May 3, 2016

SUBJECT: PIER 4 PHASE 2 RECONFIGURATION
PROJECT NO. 091251
CONTRACT NO. 070136

ADDENDUM NUMBER THREE

PIER 4 PHASE 2
RECONFIGURATION
UTILITY AND SITE DEMOLITION PLAN - SHEET 2

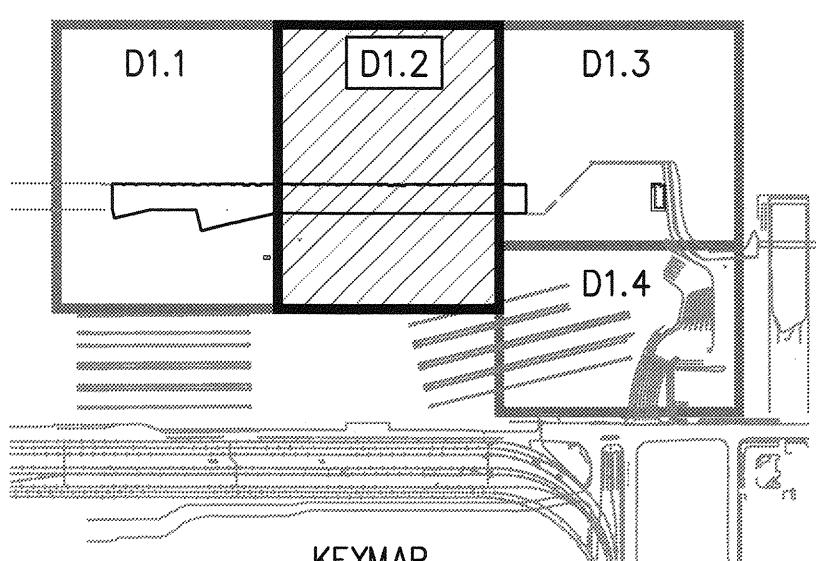
B. DRAWING D1.2 – UTILITY AND SITE DEMOLITION PLAN – SHEET 2 (SHEET 21)

1. **REVISE** Timber Bulkhead Notes and Key Notes as indicated on the revised drawing. (See Attachment D to this Addendum No. 3)

- EXPLORATORY EXCAVATION PIT #1 SHALL BE EXCAVATED FIRST. BASED ON THE FINDINGS FROM PIT #1, THE ENGINEER WILL DIRECT THE CONTRACTOR TO EITHER CONTINUE TO EXCAVATE AT THAT LOCATION OR TO BEGIN EXCAVATION AT PIT #2. PIT #3 WILL BE EXCAVATED AT THE DIRECTION OF THE ENGINEER BASED ON THE FINDINGS FROM PIT #2.
- THE CONTRACTOR SHALL REMOVE AND DISPOSE OF THE TIMBER BULKHEAD WALL SYSTEM AT THE DIRECTION OF THE ENGINEER SHOULD EXPLORATORY EXCAVATION PROVE THAT IT EXISTS. SEE SPECIFICATIONS FOR FURTHER REQUIREMENTS.
- CONTRACTOR SHALL ASSUME THAT ALL TIMBER PILES, BRACES, PLANKING, AND MISCELLANEOUS TIMBER FRAMING ELEMENTS IN THE WALL SYSTEM ARE CREOSOTE TREATED. DISPOSAL OF CREOSOTE TREATED MATERIAL SHALL BE IN ACCORDANCE WITH THE SPECIFICATIONS.
- ALL TIMBER PILES WITHIN THE AREA OF WALL SYSTEM REMOVAL SHALL BE COMPLETELY EXTRACTED. (APPROX. 280)

31 6' DEEP EXPLORATORY EXCAVATION PIT FOR BURIED TIMBER BULKHEAD WALL SYSTEM. SEE SHEET D2.2 FOR HORIZONTAL CONTROL. PITS TO BE BACKFILLED AND COMPAKTED PER SPECIFICATIONS.

32 POSSIBLE BURIED TIMBER BULKHEAD WALL SYSTEM OUTLINE, APPROX. 700'x60'. SEE TIMBER BULKHEAD NOTES.

PIER 4 PHASE 2 RECONFIGURATION SLOPE PROTECTION PLAN

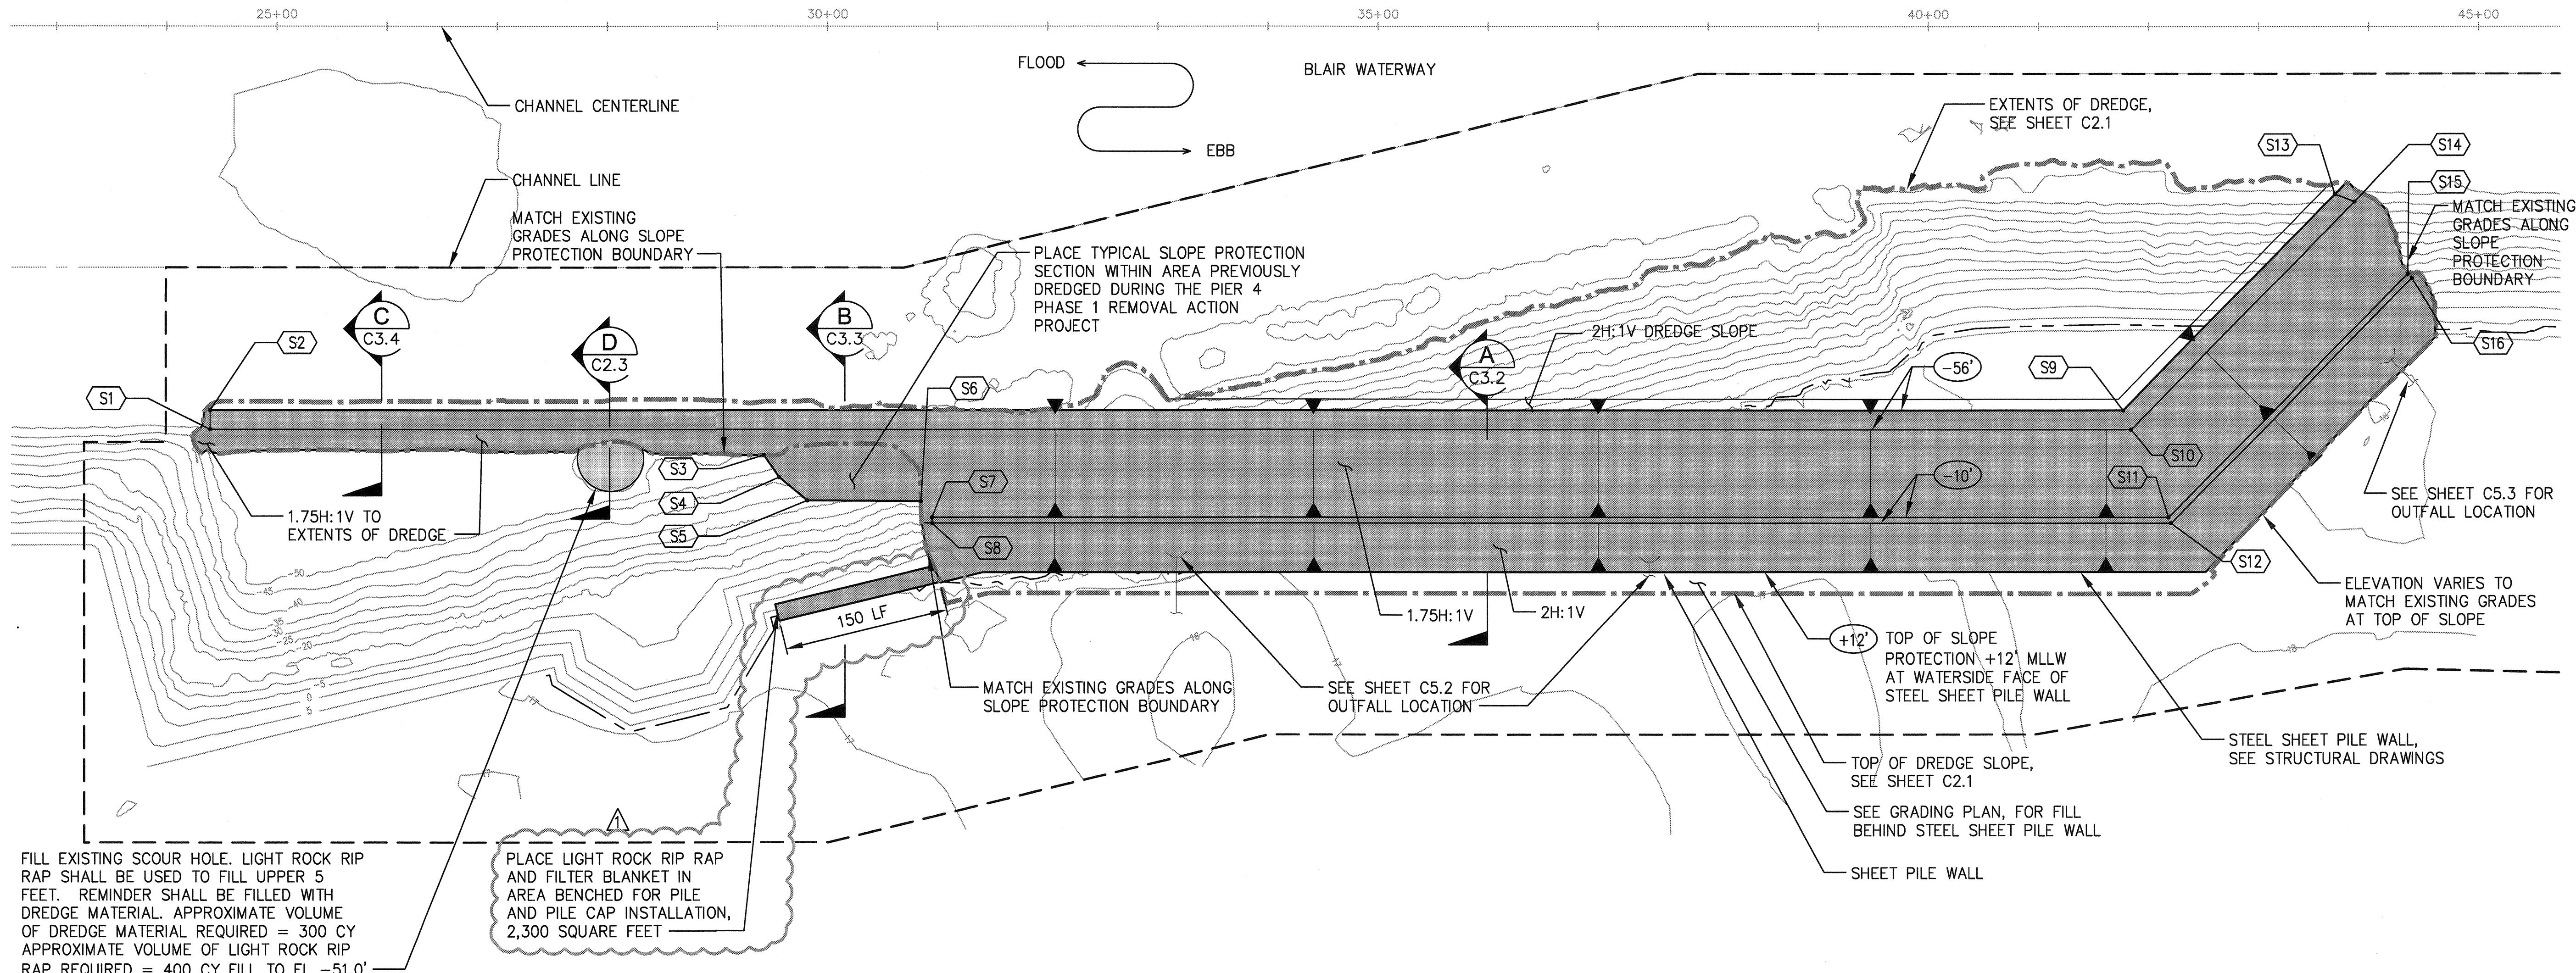
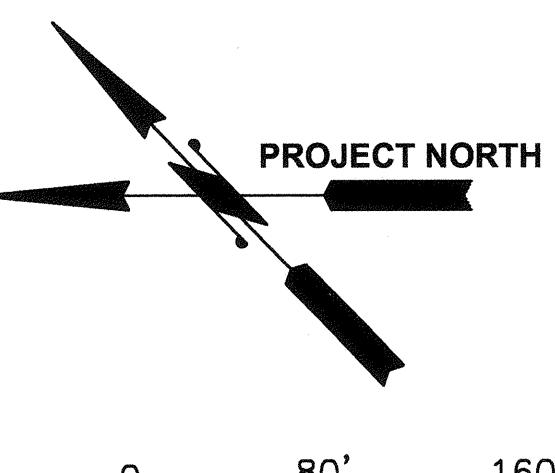
C. DRAWING C3.1 – SLOPE PROTECTION PLAN (SHEET 52)

1. **ADD** light rock rip rap and filter blanket in specified area benched for pile and pile cap installation, 2,300 square feet. (See Attachment E to this Addendum No. 3)

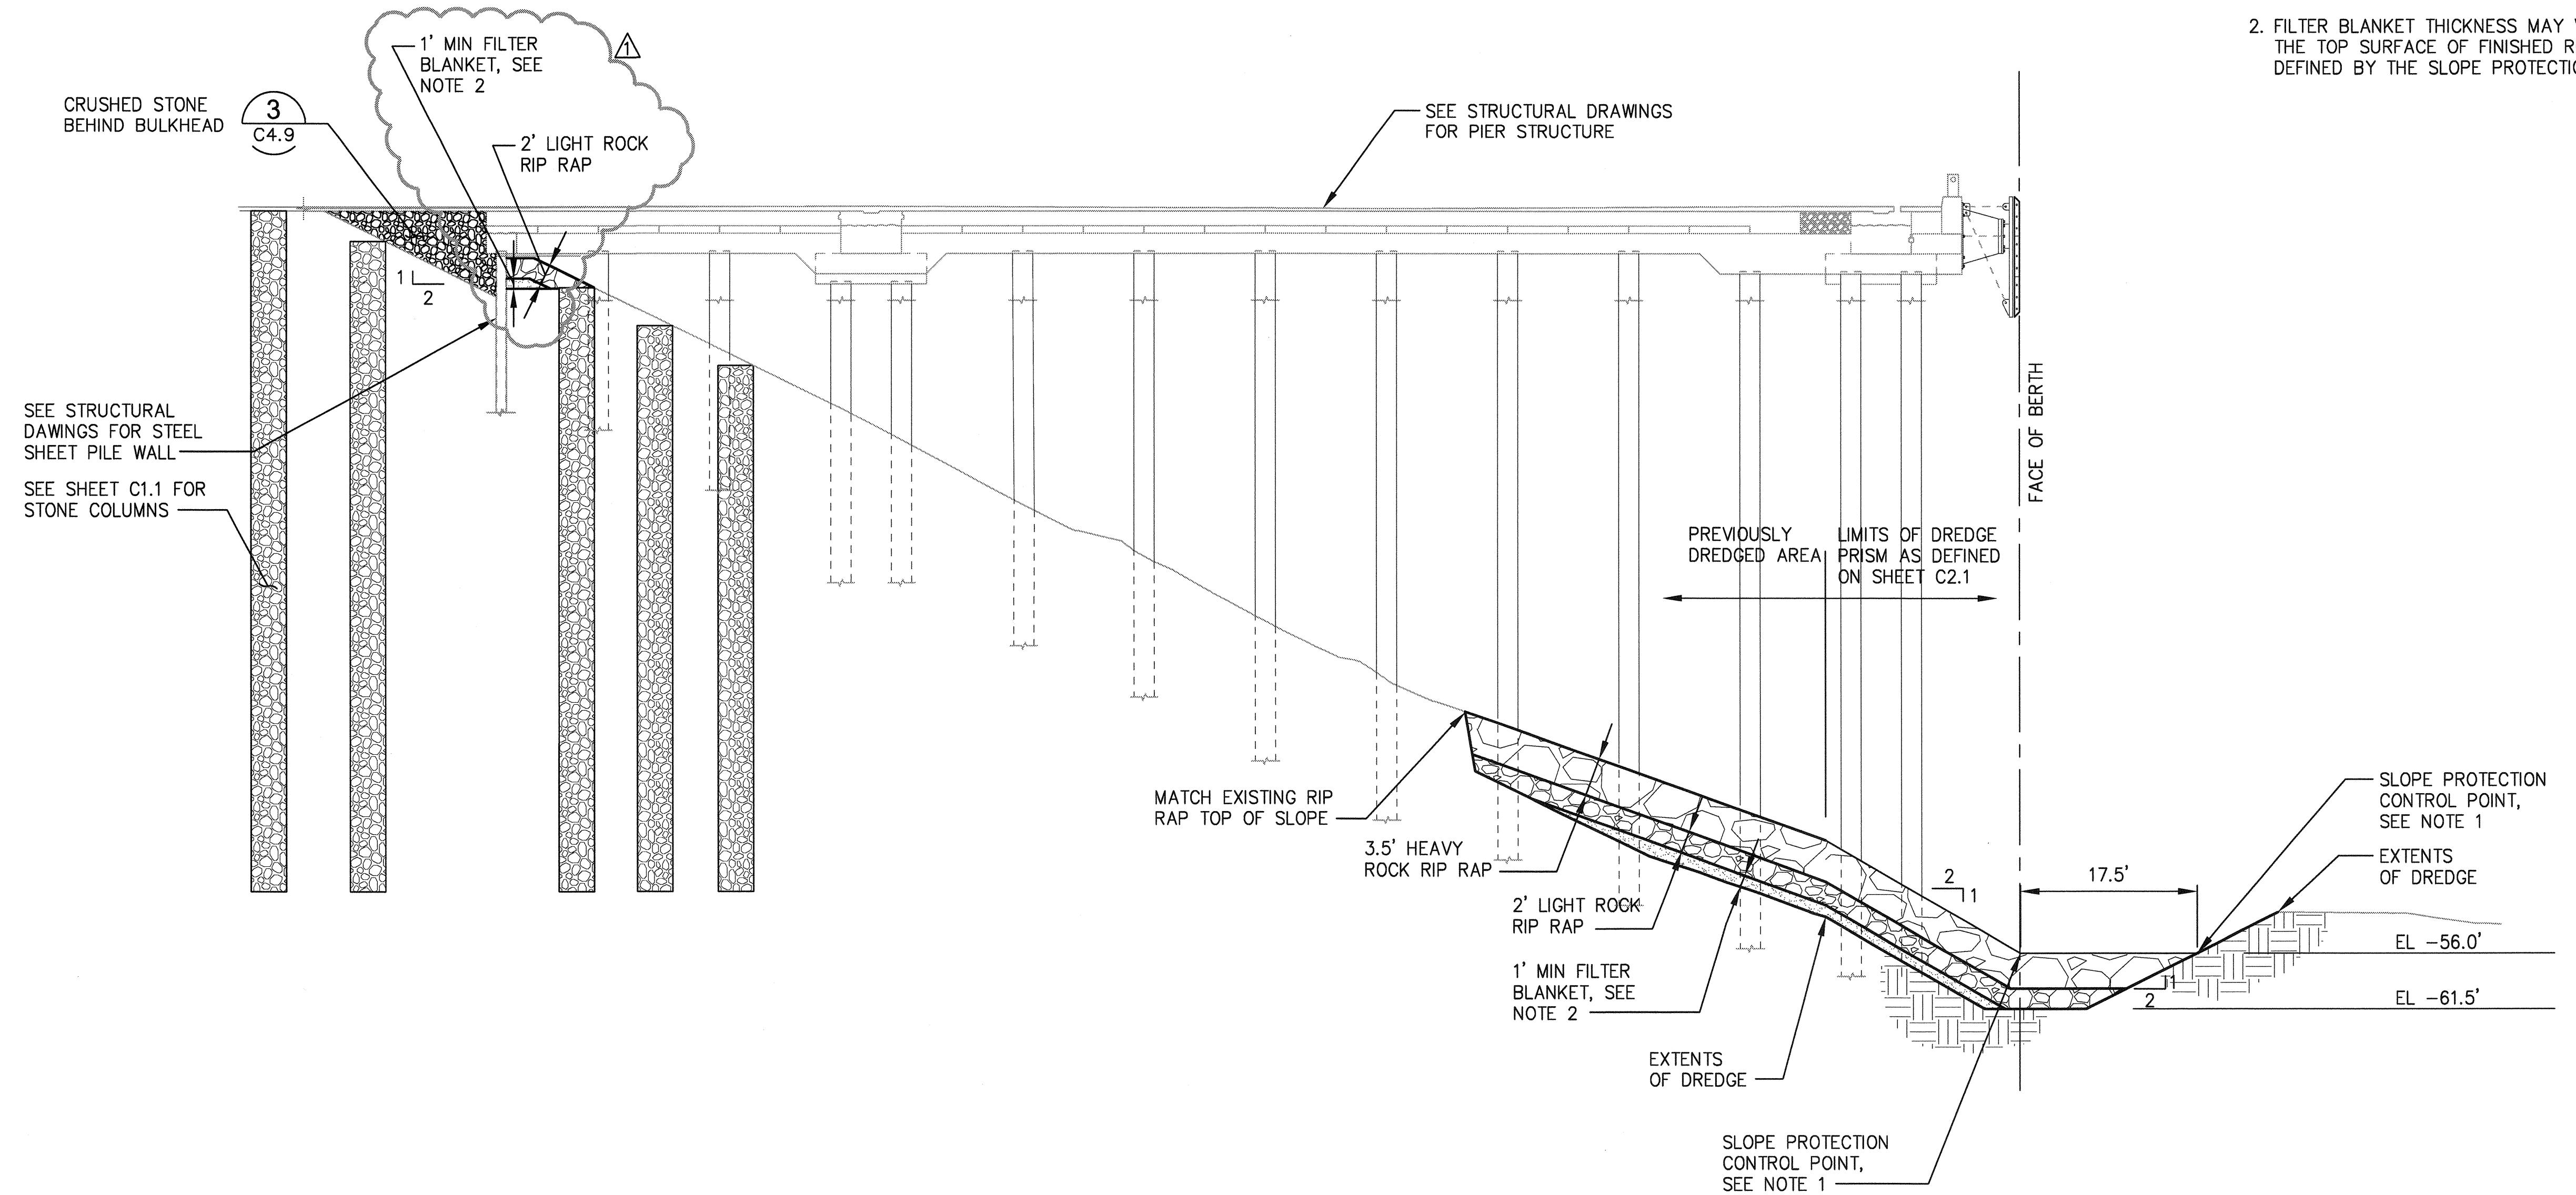
D. DRAWING C3.3 – SLOPE PROTECTION SECTIONS – SHEET 2 (SHEET 54)

1. **ADD** light rock rip rap and filter blanket waterside of bulkhead as denoted. (See Attachment F to this Addendum No. 3)

PILE AND PILE CAP PLAN

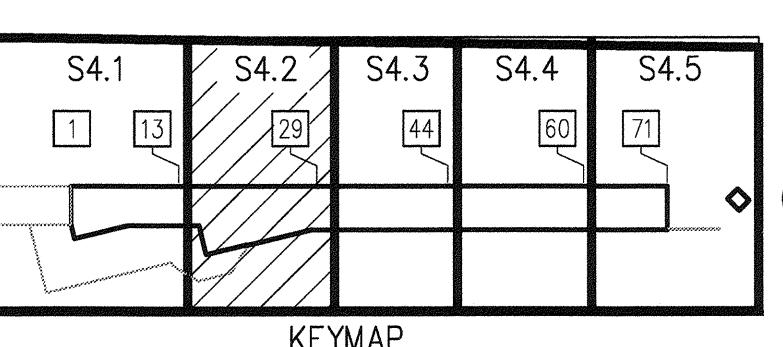
F. DRAWING S4.2 – PILE AND PILE CAP PLAN – SHEET 2 (SHEET 180)

1. **REPLACE** entire sheet with attached sheet to include existing slope contours. (See Attachment G to this Addendum No. 3)

TYPICAL CRANE BEAM PANEL TYPE "L" SECTION P2A

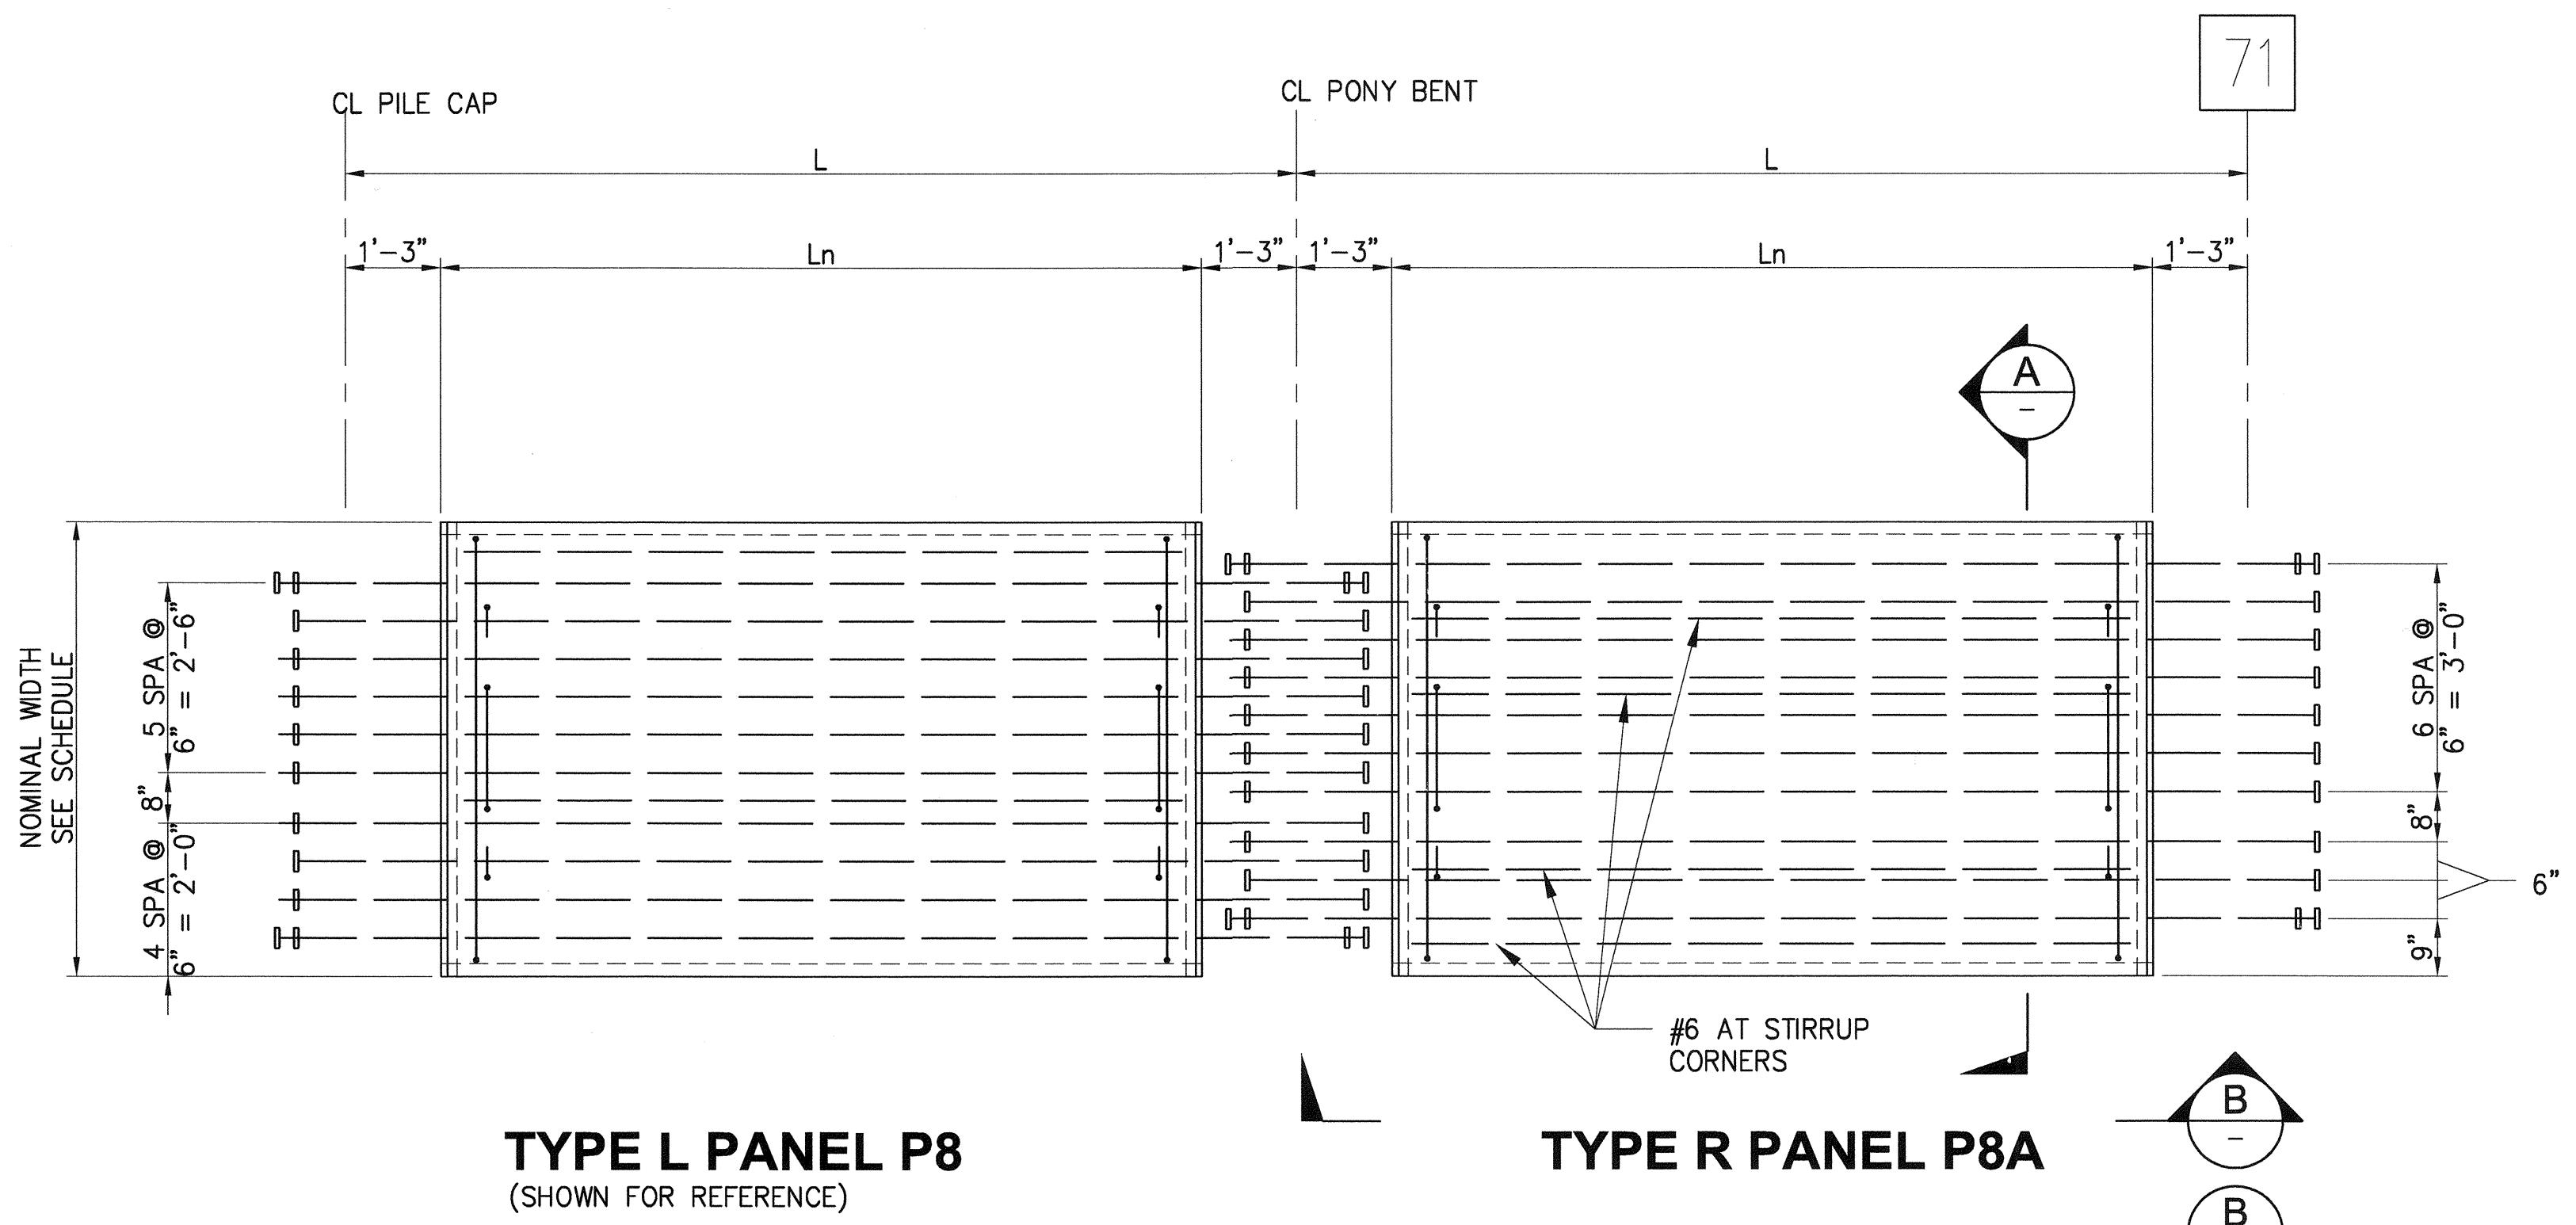
G. DRAWING S27.45 – DECK PANEL DETAILS – SHEET 45 (SHEET 340)

1. **REVISE** Detail A Typical Crane Beam Panel Type “L” Section P2A and Detail B Typical Type “R” Crane Beam Panel Elevation as denoted. (See Attachment H to this Addendum No. 3)
